MIL-P-17639F (SH)
AMENDMENT 4
22 FEBRUARY 1996
SUPERSEDING
AMENDMENT 3
25 May 1995

PUMPS, CENTRIFUGAL, MISCELLANEOUS SERVICE,
NAVAL SHIPBOARD USE

This amendment forms a part of MIL-P-17639F(SH), dated 18 February 1986, and is approved for use within the Naval Sea Systems Command, Department of the Navy and is available for use by all Departments and Agencies of the Department of Defense.

FIGURE 1A - IMPELLER BETWEEN BEARINGS

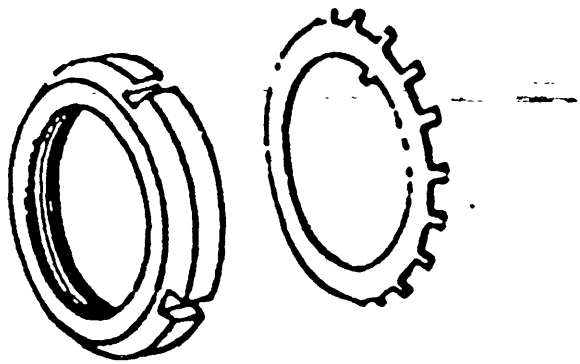
“3.3.5.2 Impellers shall be keyed or, the shaft and securely held against movement by locked nuts or other means approved by the design review agency (see 6.2.1). Impellers between bearings shall be restrained in a manner similar to that shown in Figure 1A. Impellers not between bearings shall be restrained in a manner similar to that shown in Figure 1B."
